February 8, 2022

RE: Diggerland USA 1, LLC.
Diggerland Adventure Park
Amended Site Plan for New Attraction
Block 2601, Lot 1, & 5
Property address: 100 Pinedge Drive
Township of Berlin, Camden County, New Jersey

From: Yan Giriya
Sent: Wednesday, February 2, 2022 1:10 PM
To: Chuck Ribbal - Township of West Beira (municipalengineer@berlinwp.com)
Subject: Discontinued New Stationary Ride
Attachments: 2022-01-24_Diggerland-2022Canes.pdf

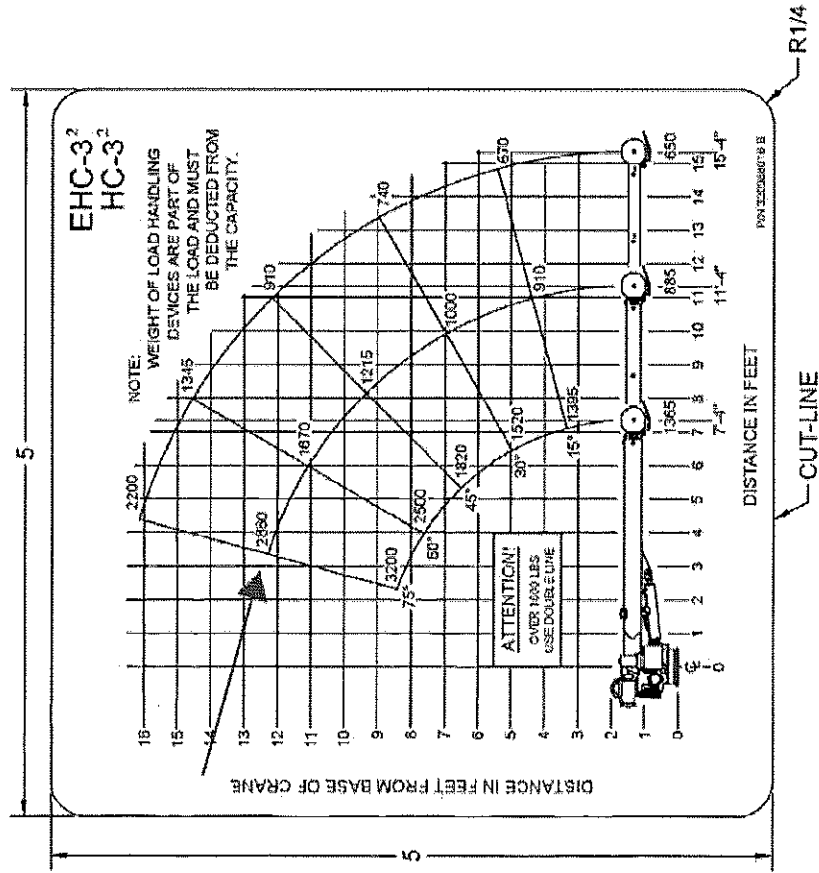
1. Maximum height of crane
2. Ground surface material?
3. Access route to the amusement ride?
4. What does the crane pick up and where will these items be placed?
5. Since it appears to be encroaching into the limits of the existing ride, will there be modifications to the limits of the existing ride? What prevents a rider, within the existing ride, from crashing into the proposed crane ride?

As discussed, this is a new ride which we will need a foundation and electrical work. The ride will be installed behind the existing pavilion building (Block 2601, Lot1). Below is an aerial plan indicating the 4 rides. The total area of the green and purple blocks 24.5' x 84' = 2,058 SF. Looking forward to hearing from you. Thank you.
